ADDENDUM No. 01

Coaldale Government Building

Project No.: 9030

Project:	Coaldale Protective Services Building	File No.	841-004
Client:	Stephens Kozak – ACI Architects and Planners	Addendum No.	S1
Copy:		Date:	February 12, 2019

Suite 200, 4220-98 Street NW Edmonton, AB T6E 6A1 (780) 436-5376 www.bptec.ca	PROJECT: STEPHENS KOZAK ACI ARCHITECTS COALDALE PROTECTIVE SERVICES BUILDING		
	DRG. TITLE: REVISED SECTION 1		
DRAWN: NM	DATE: FEB. 12, 2019	FILE No.: 841-004	SKETCH No.: SSK-004

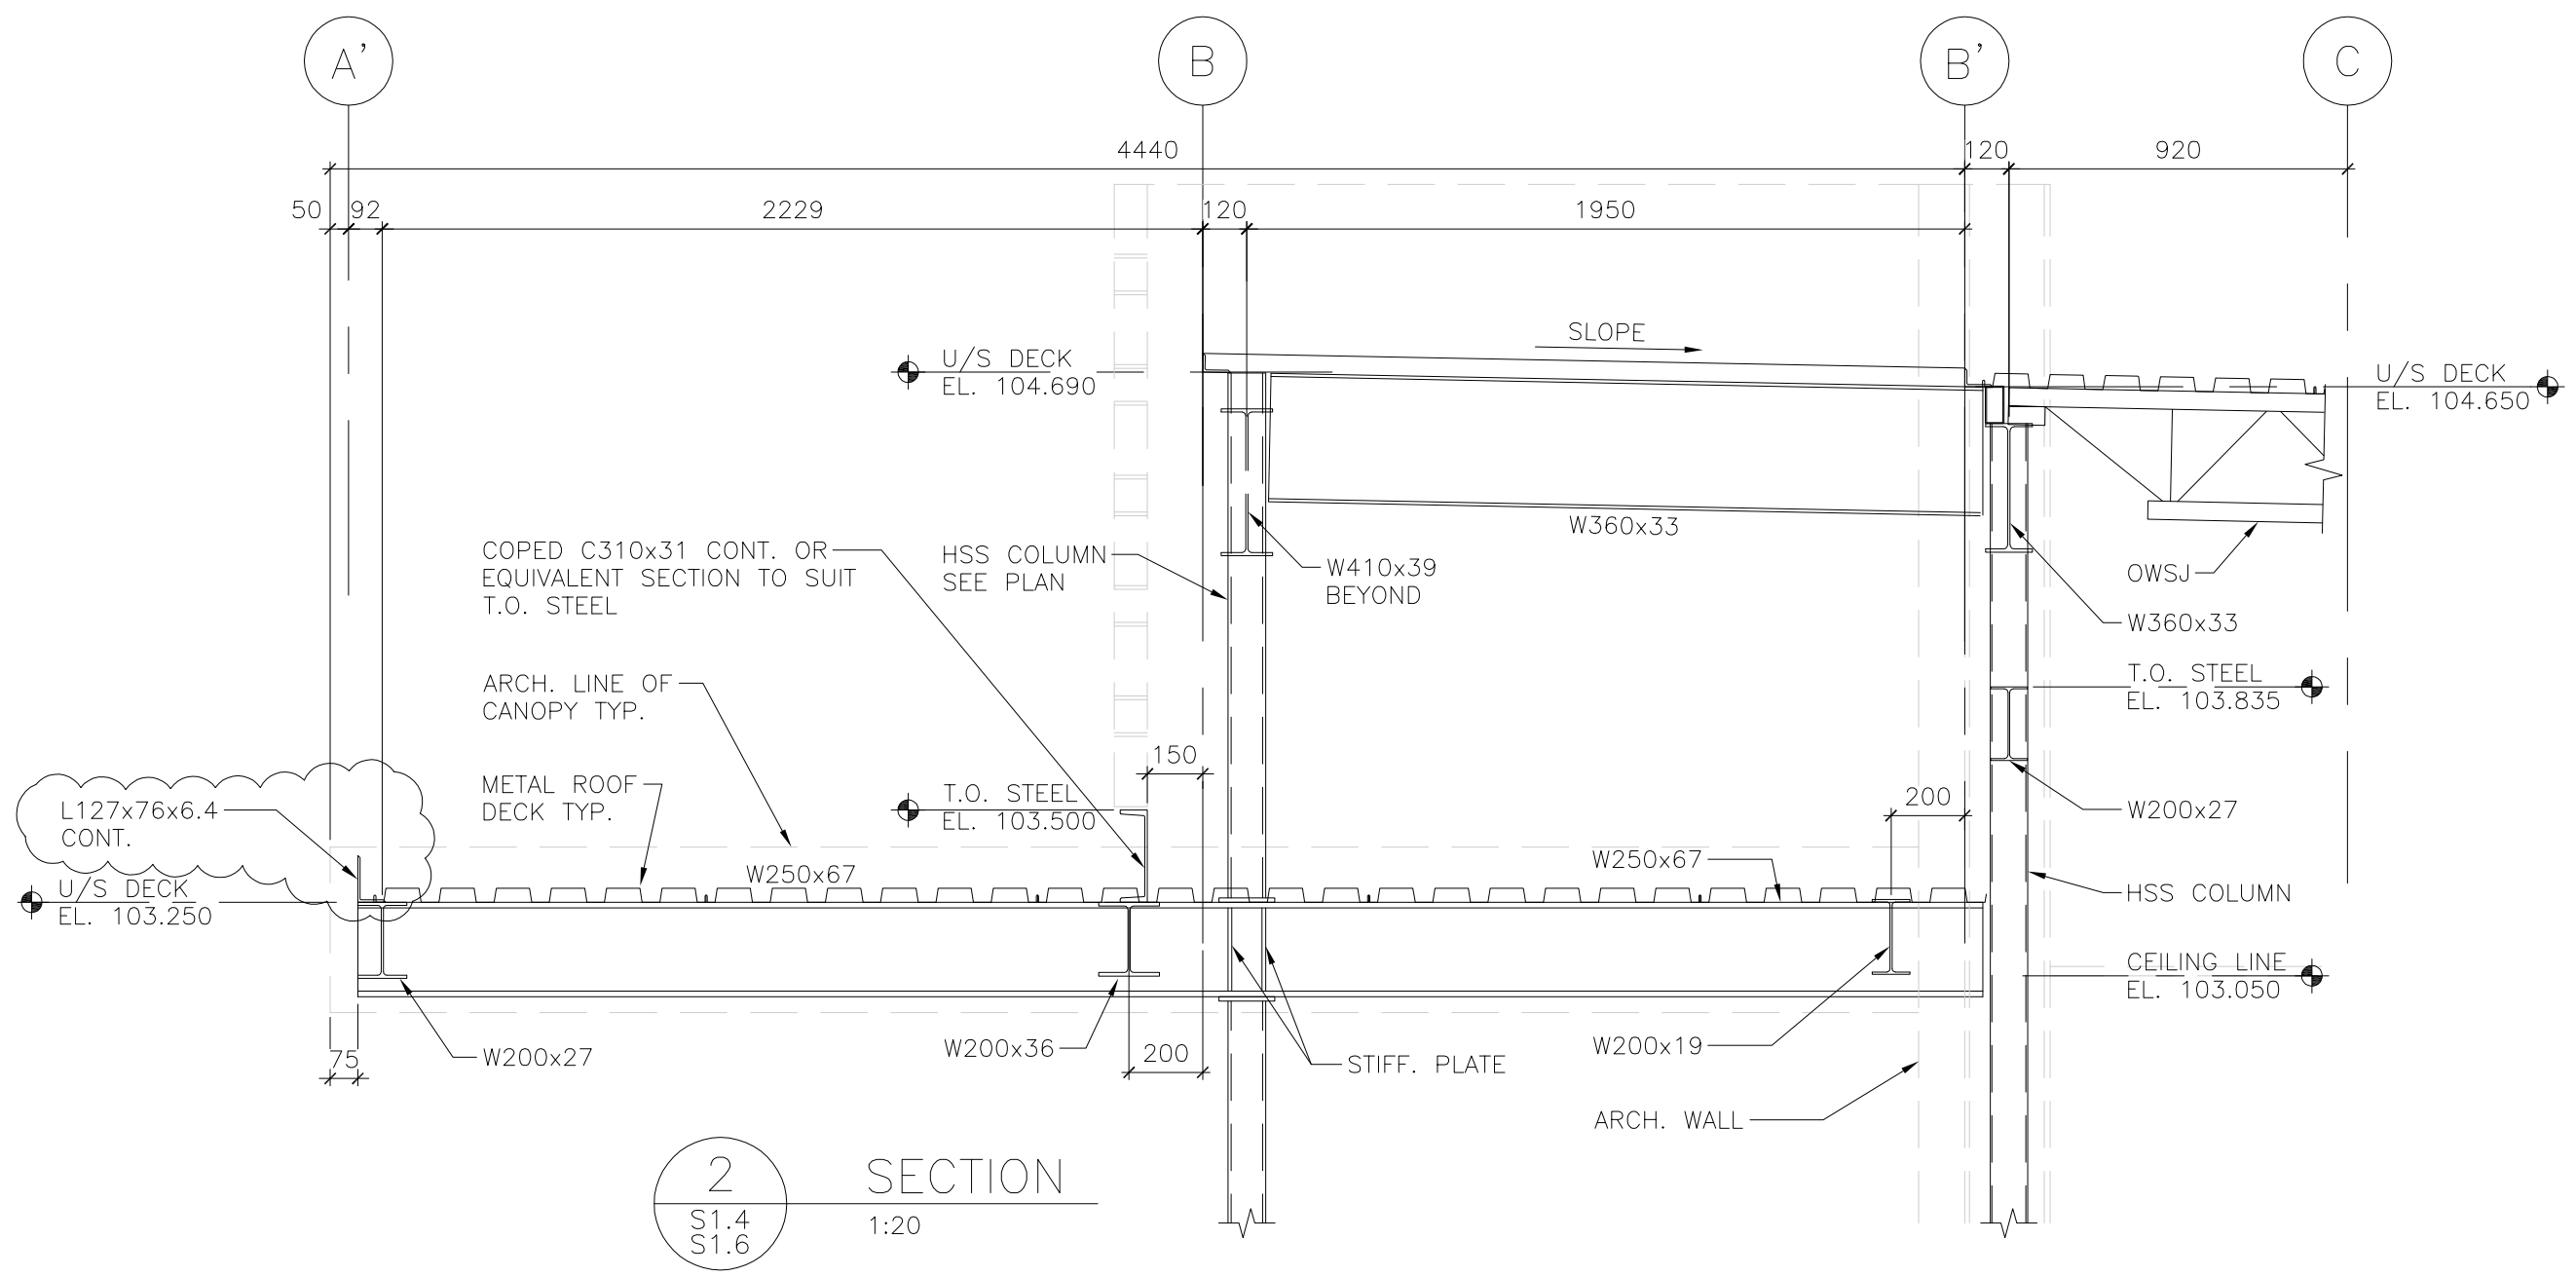
- .8.3 On section 10, add axial forces of 75 kN in horizontal and diagonal braces (HSS 102x102x13).
Delete 'U/S Girt' elevation.
- .8.4 On section 1, delete L51x51x6.4 and add L127x76x6.4 as clouded on SSK-004.

<p> Suite 200, 4220-98 Street NW Edmonton, AB T6E 6A1 </p>	<p> PROJECT: STEPHENS KOZAK ACI ARCHITECTS COALDALE PROTECTIVE SERVICES BUILDING </p>		
	<p> DRG. TITLE: REVISED SECTION 2 </p>		
<p> DRAWN: NM </p>	<p> DATE: FEB. 12, 2019 </p>	<p> FILE No.: 841-004 </p>	<p> SKETCH No.: SSK-005 </p>

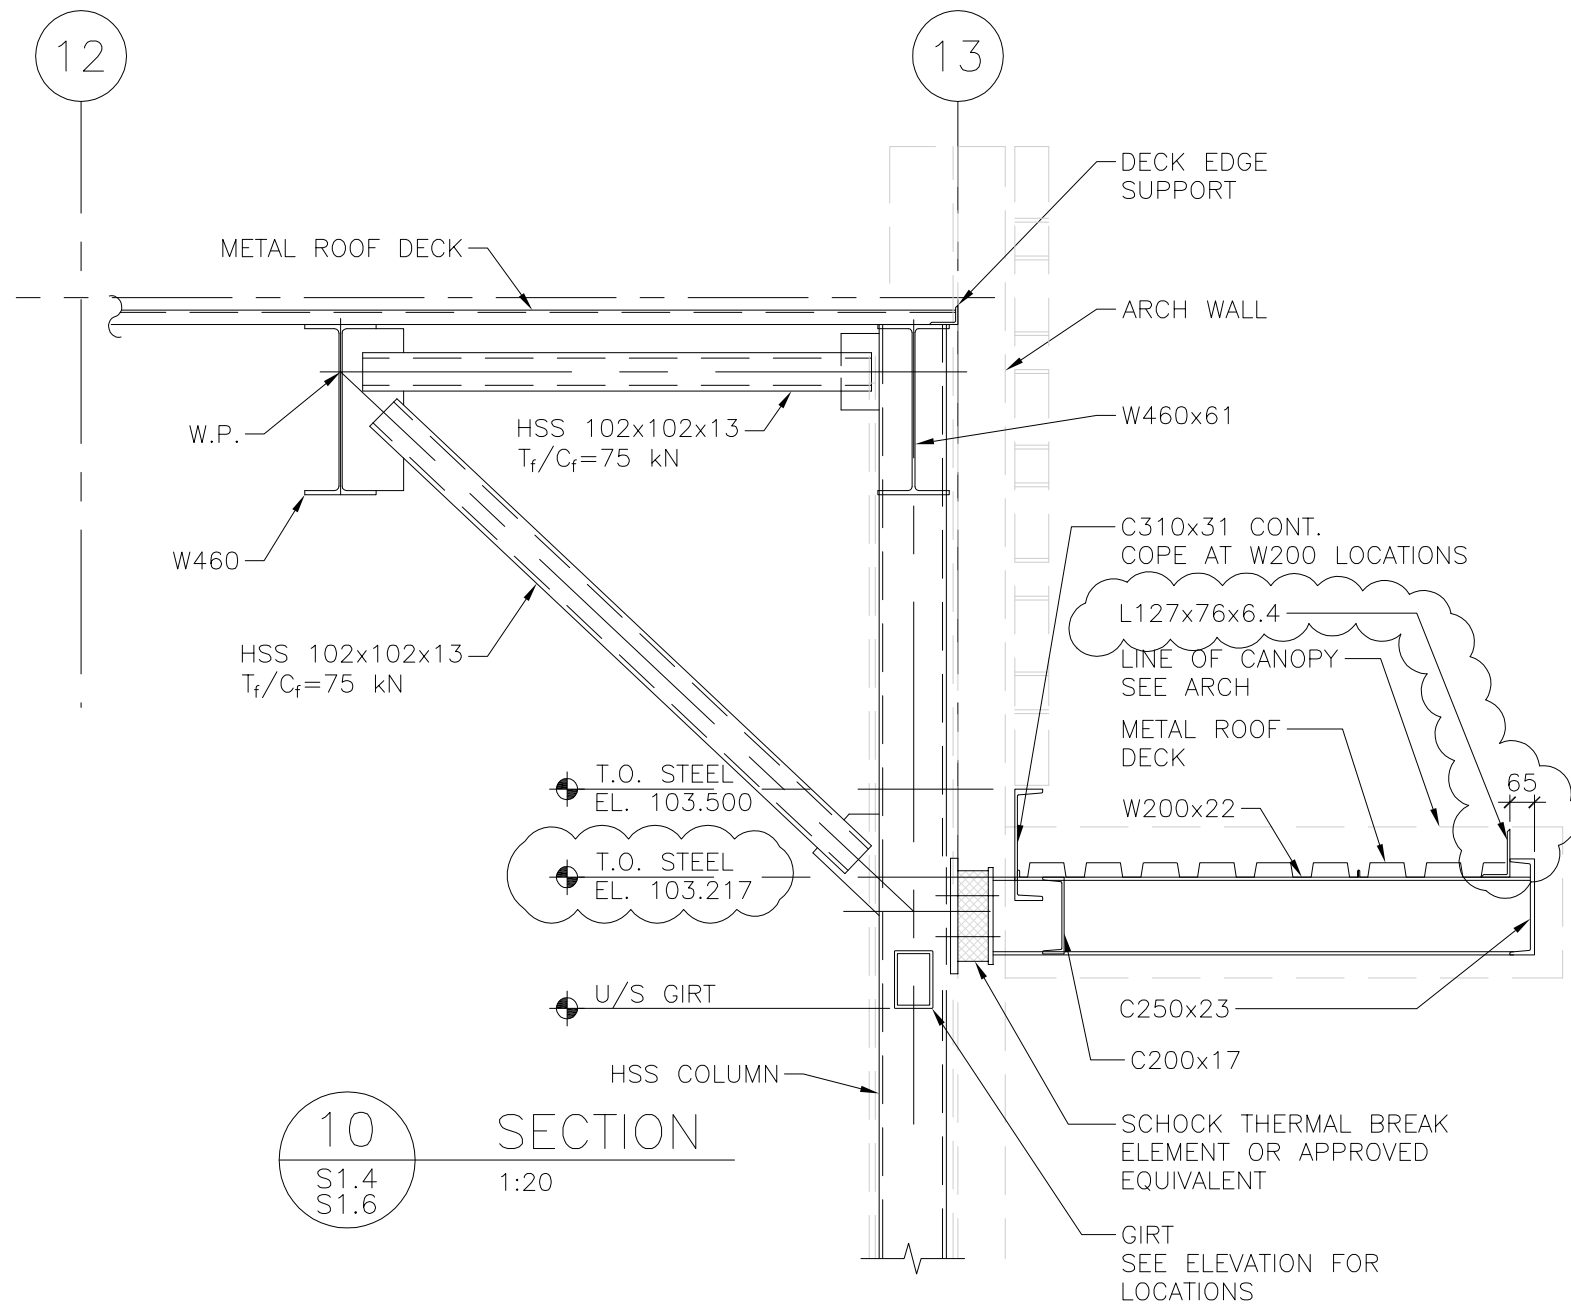
- .8.5 On section 2, delete L51x51x6.4 and add L127x76x6.4 as clouded on SSK-005.
- .8.6 On section 10, delete L51x51x6.4 and add L127x76x6.4 as clouded on SSK-006.

PROJECT :				STEPHENS KOZAK ACI ARCHITECTS COALDALE PROTECTIVE SERVICES BUILDING			
DRG. TITLE :				REVISED SECTION 15 ON S3.2			
DRAWN :		DATE :		FILE No. :		SKETCH No. :	
NM		FEB. 12, 2019		841-004		SSK-007

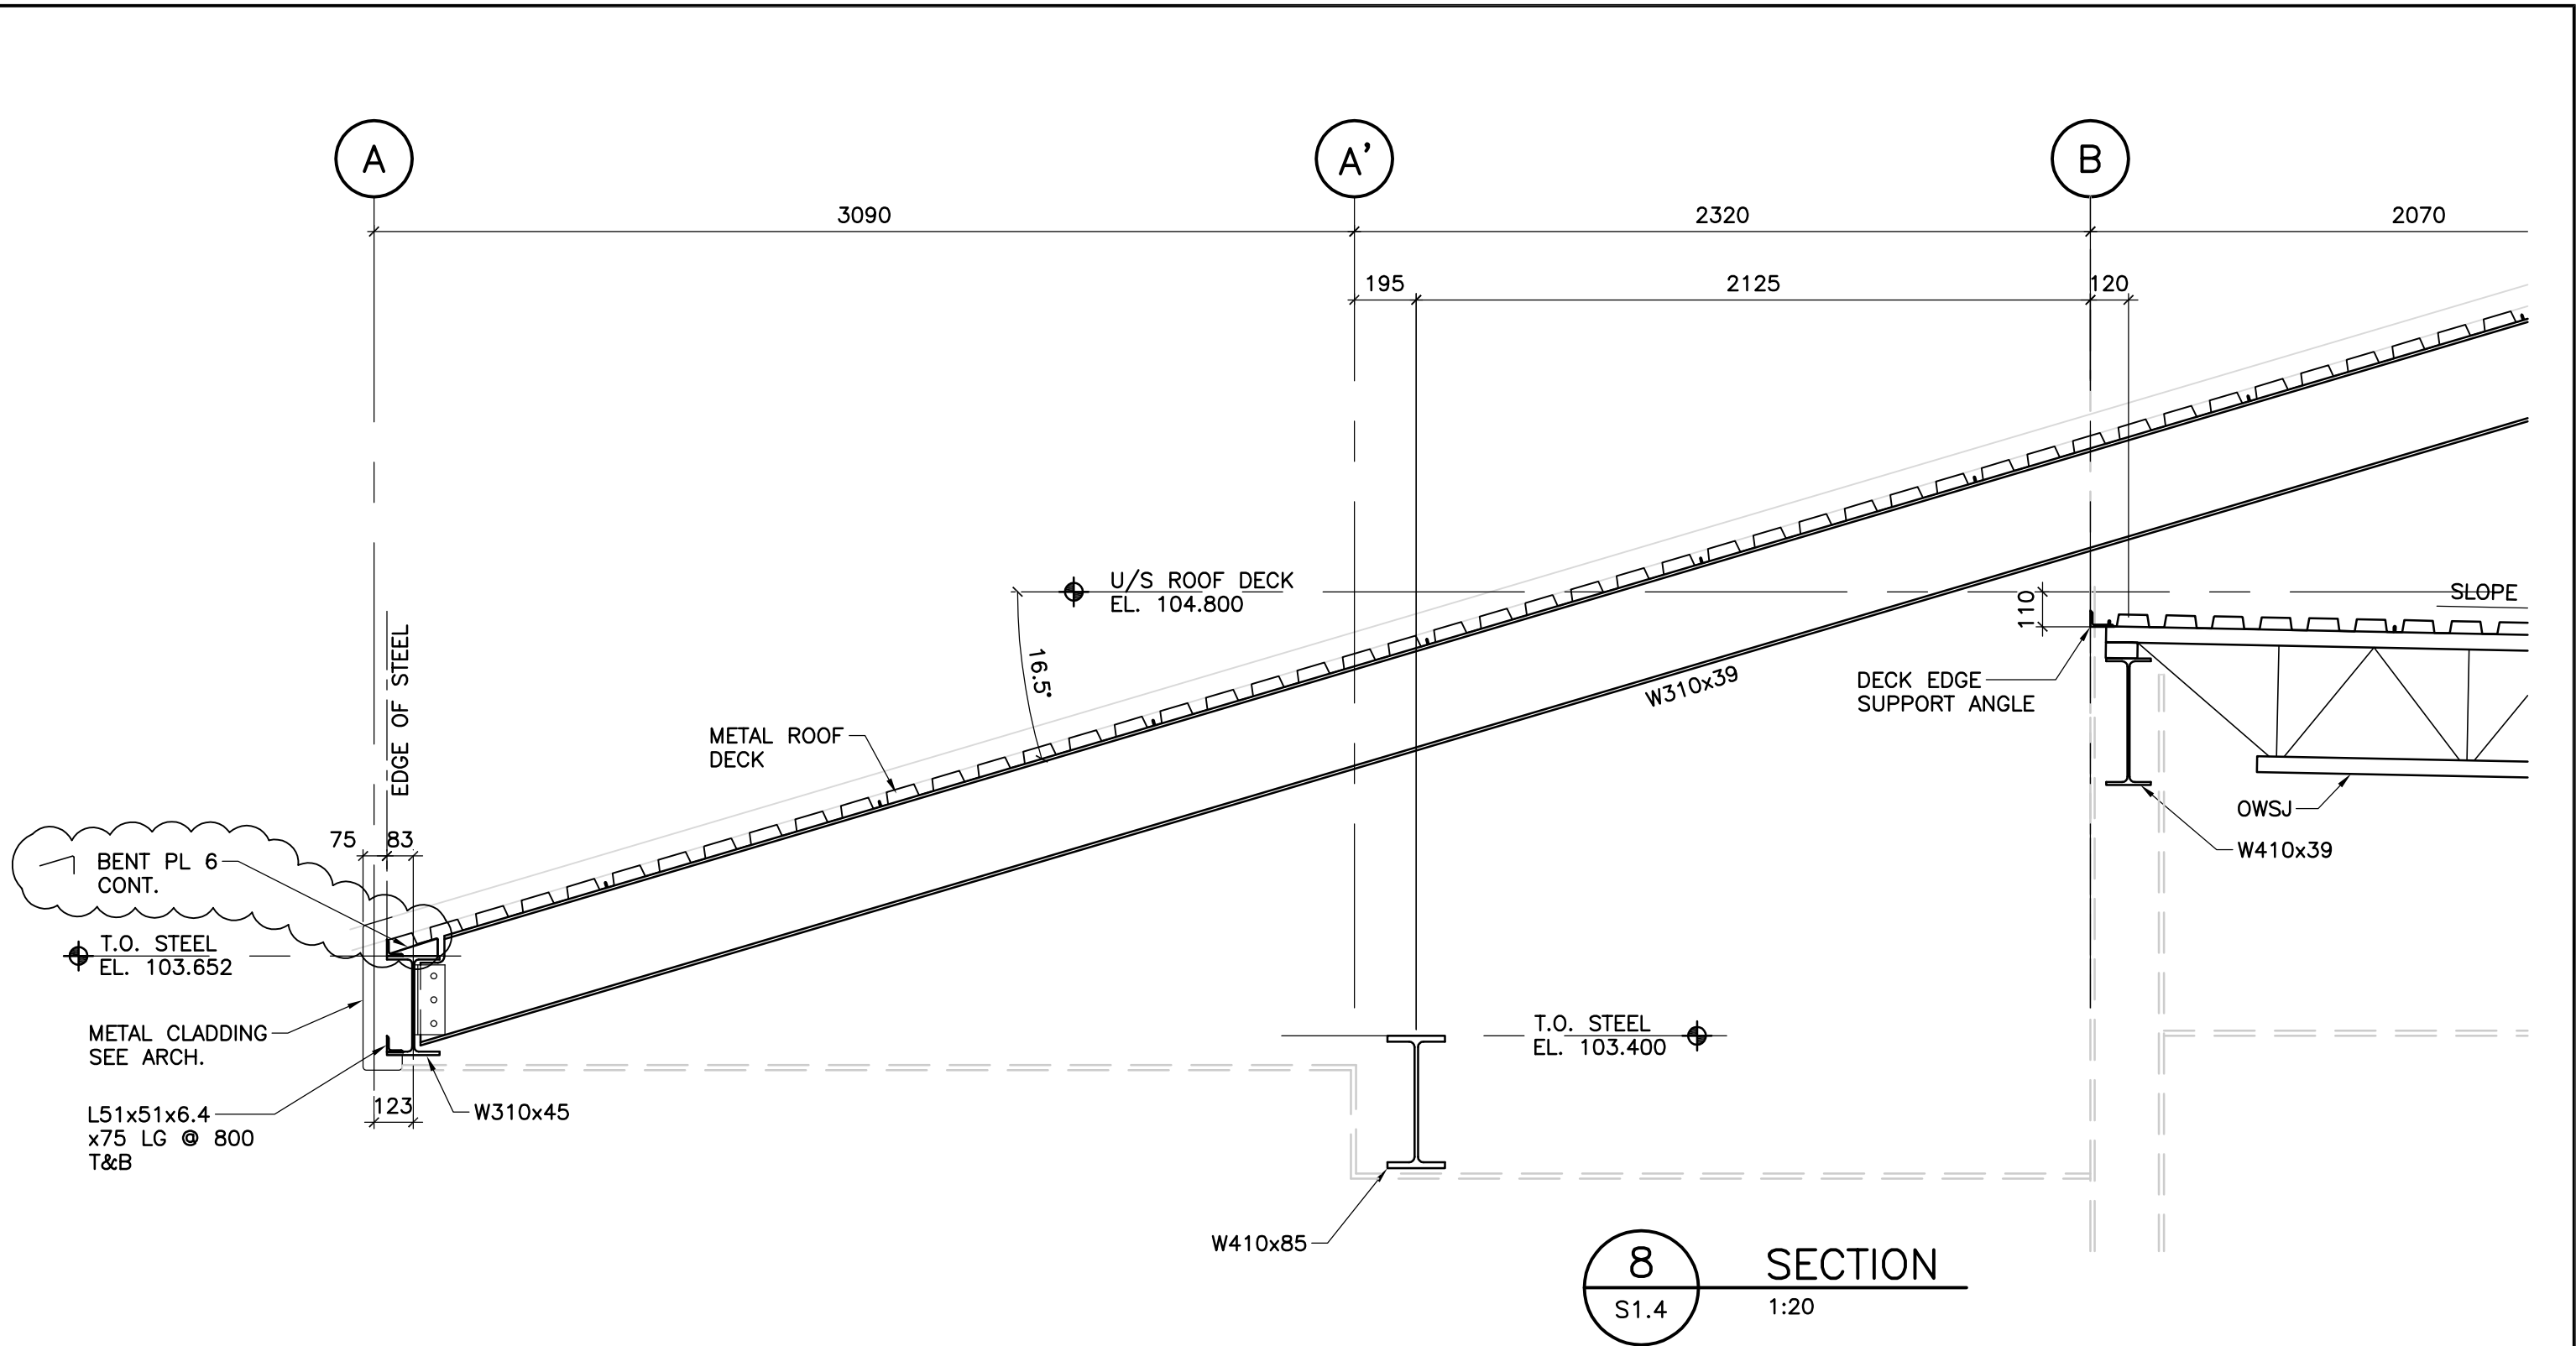
.9.1 On section 15, delete L51x51x6.4 and add L127x76x6.4 as clouded on SSK-007.

<p>Suite 200, 4220-98 Street NW Edmonton, AB T6E 6A1</p> <p>(780) 436-5376 www.bptec.ca</p>	PROJECT : STEPHENS KOZAK ACI ARCHITECTS COALDALE PROTECTIVE SERVICES BUILDING		
	DRG. TITLE : REVISION TO SECTION 8 ON S3.3		
DRAWN : NM	DATE : FEB. 12, 2019	FILE No. : 841-004	SKETCH No. : SSK-008

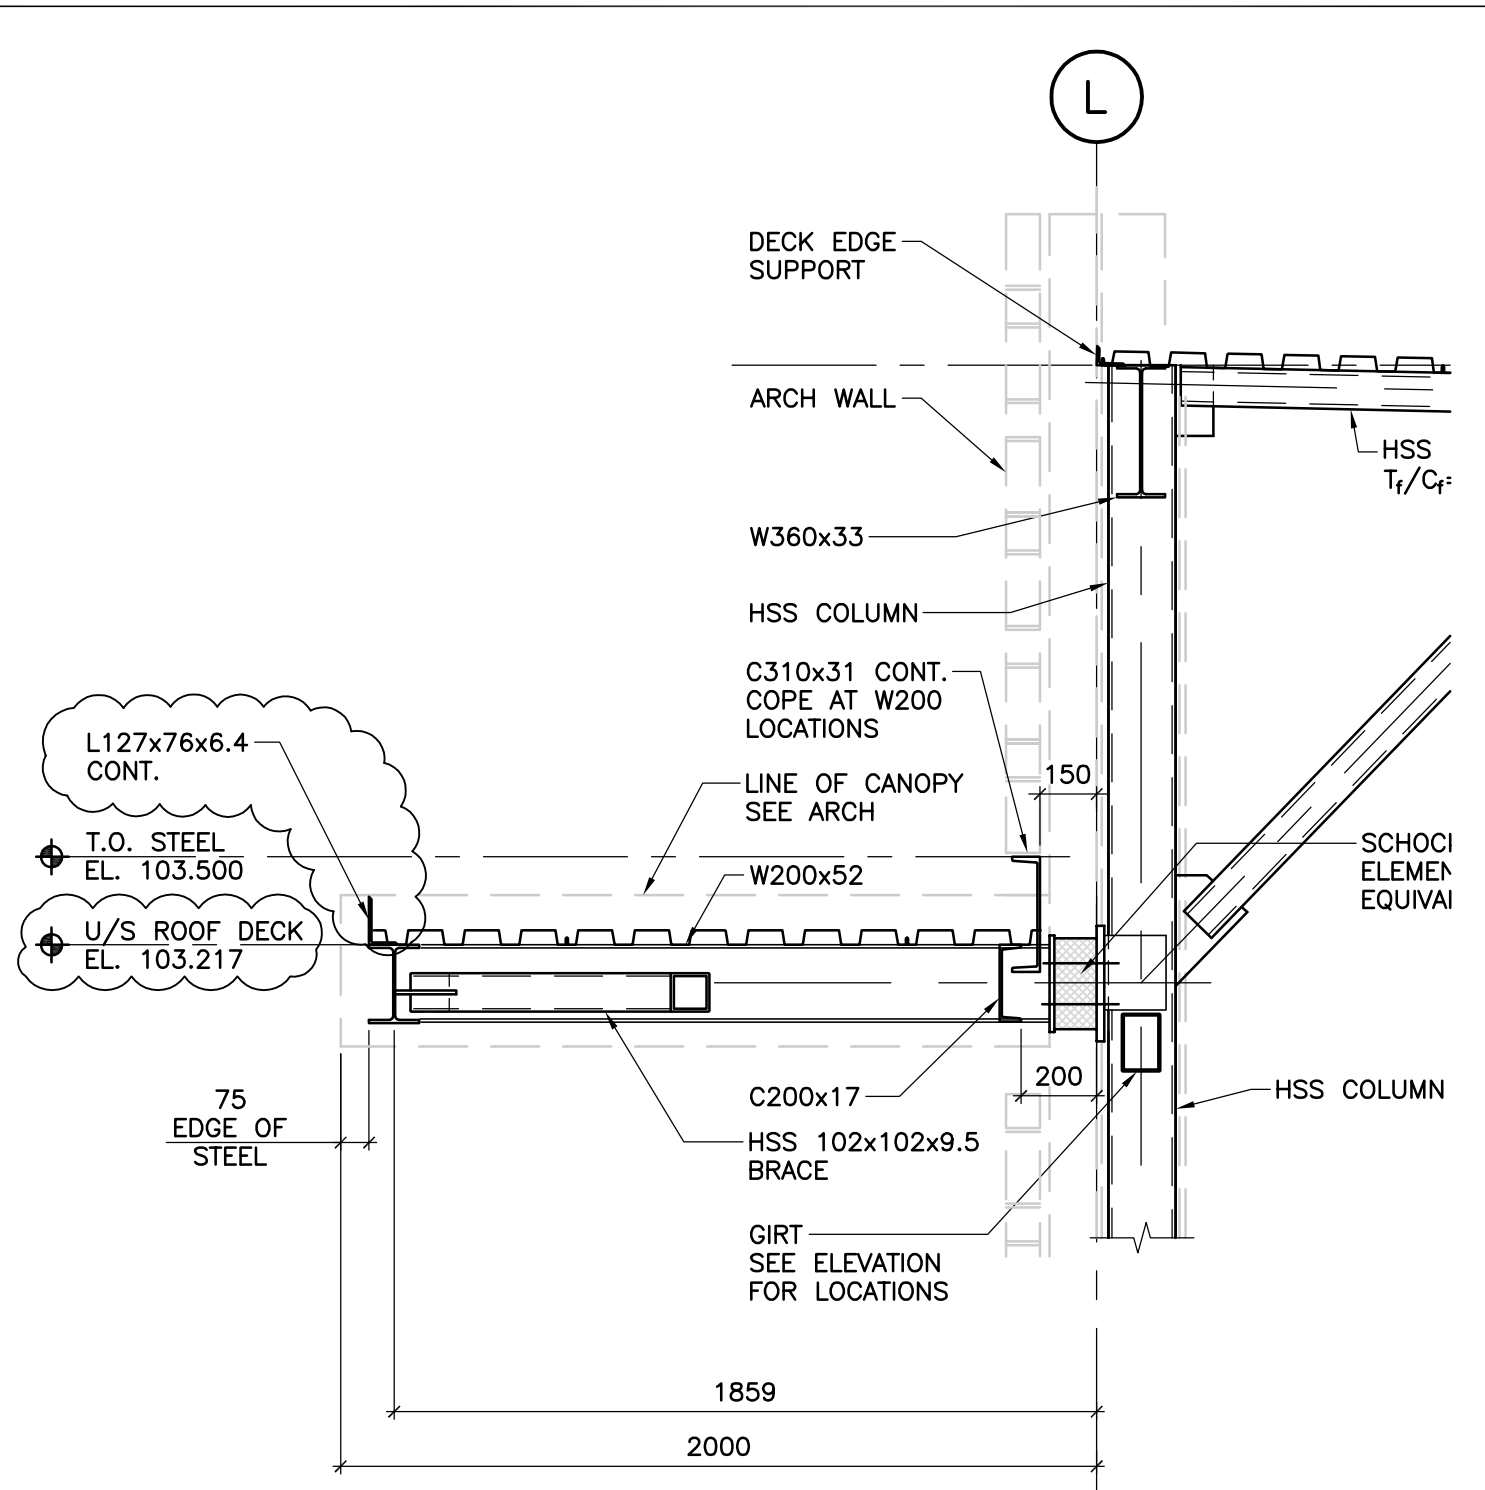
.10.4 On section 8, add bent plate PL 6 at end of sloped W310x39 beam as clouded on SSK-008.
